**Economic and Social Council**Distr.: General
17 February 2022

World Forum for Harmonization of Vehicle Regulations**Working Party on Passive Safety Provisions****Seventy-first session**

UN Regulation No. 129 (Enhanced Child Restraint Systems)**Proposal for Supplement 8 to the 02 series of amendments****Submitted by the expert from the European Association of Automotive Suppliers***

Figure 1
Conditioning for adjusters mounted directly on Enhanced Child Restraint Systems

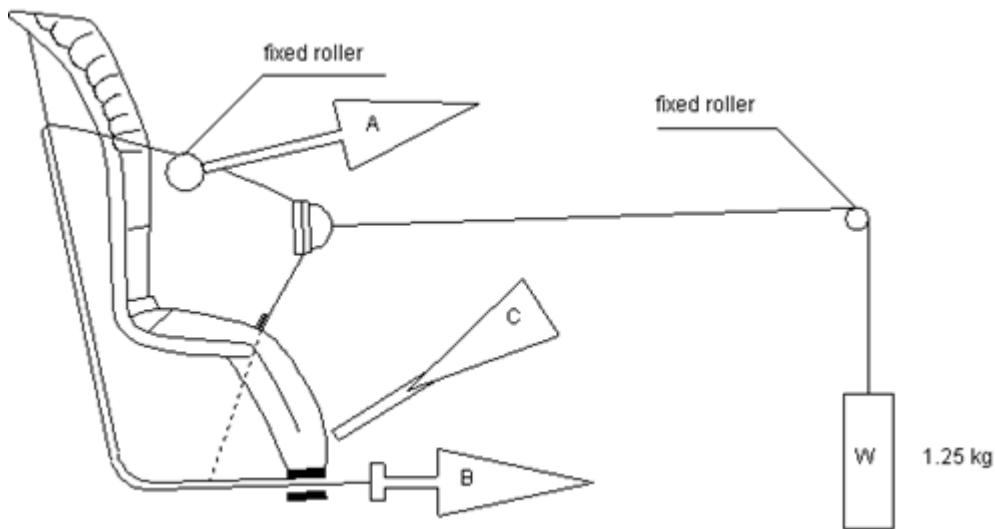
1. **Conditioning for adjusters mounted directly on Enhanced Child Restraint Systems (Figure 1)**
 - 1.1. **Method**
 - 1.1.1. **With the webbing set at the reference position described in paragraph 7.2.6.1., withdraw at least 50 mm of webbing from the integral harness by pulling on the free end of the webbing.**
 - 1.1.2. **Attach the adjusted part of the integral harness to the pulling device A.**
 - 1.1.3. **Activate the adjuster and pull at least 150 mm of webbing into the integral harness. This represents half of one cycle and puts pulling device A to the maximum webbing extraction position.**
 - 1.1.4. **Connect free end of webbing to pulling device B.**
 - 1.2. **The procedure of the cycle is:**

- 1.2.1. Pull B at least 150 mm while A exerts no tension on the integral harness.
- 1.2.2. Activate the adjusters and pull A while B exerts no tension on the free end of the webbing.
- 1.2.3. At the end of stroke, de-activate the adjuster.
- 1.2.4. Repeat cycle as specified in paragraph 6.7.2.7. of this Regulation.

The amendments to paragraph 6.7.2.7. and to Annex 15 correct editing mistakes that were introduced by proposals adopted at the sixty-first session of the Working Party on Passive Safety (GRSP) and subsequently entered into force in the 01 and 02 series of amendments to UN Regulation No. 129. The amendment to paragraph 6.7.2.7. introduces changes agreed at the above-mentioned session of GRSP that were implemented in the 01 series of amendments but erroneously omitted from the 02 series (and subsequently to the 03 series). The amendment to Annex 15 reinstates a figure and procedure for testing adjusters

mounted directly on the Enhanced Child Restraint System, which was mistakenly overwritten, instead of added to, by a figure and procedure for testing adjusters connected to a strap.

Figure 2
Conditioning for adjusters connected to a strap (not directly mounted on Enhanced Child Restraint Systems)

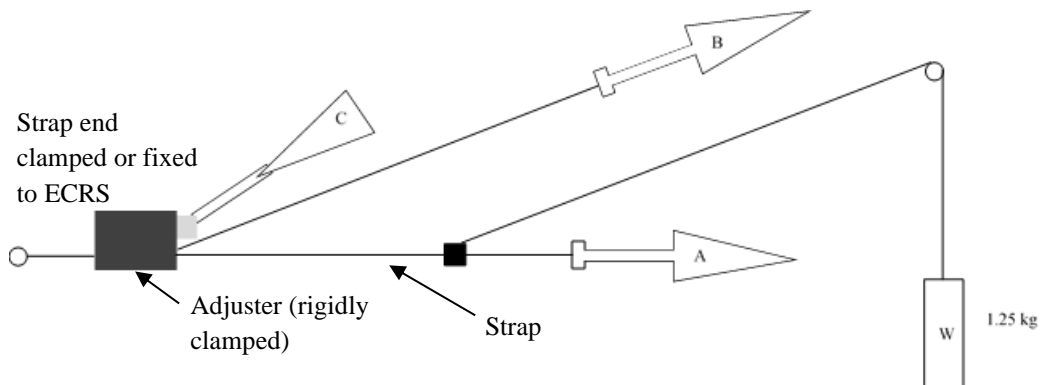
2. **Conditioning for adjusters connected to a strap (not directly mounted on Enhanced Child Restraint Systems) (Figure 2)**
 - 2.1. Method
 - 2.1.1. Rigidly clamp the adjuster

- 2.1.2. With the strap set at the reference position described in paragraph 7.2.6.2., withdraw at least 50 mm of strap from the adjuster by pulling on the free end of the strap.

- 2.1.3. Attach the adjuster part of the strap to the pulling device A.
 - 2.1.4. Activate the adjuster (C) and pull at least 150 mm of strap through the adjuster. This represents half of one cycle and puts pulling device A to the maximum strap extraction position.

- 2.1.5. Connect the free end of the strap to pulling device B.
 - 2.2. The cycle is:
 - 2.2.1. Pull B at least 150 mm while A does not exert tension on the strap.

- 2.2.2. Activate the adjuster (C) and pull A while B does not exert tension on the free end of the strap.
 - 2.2.3. At the end of the stroke, de-activate the adjuster.

- 2.2.4. Repeat the cycle as specified in paragraph 6.7.2.7. of this Regulation."
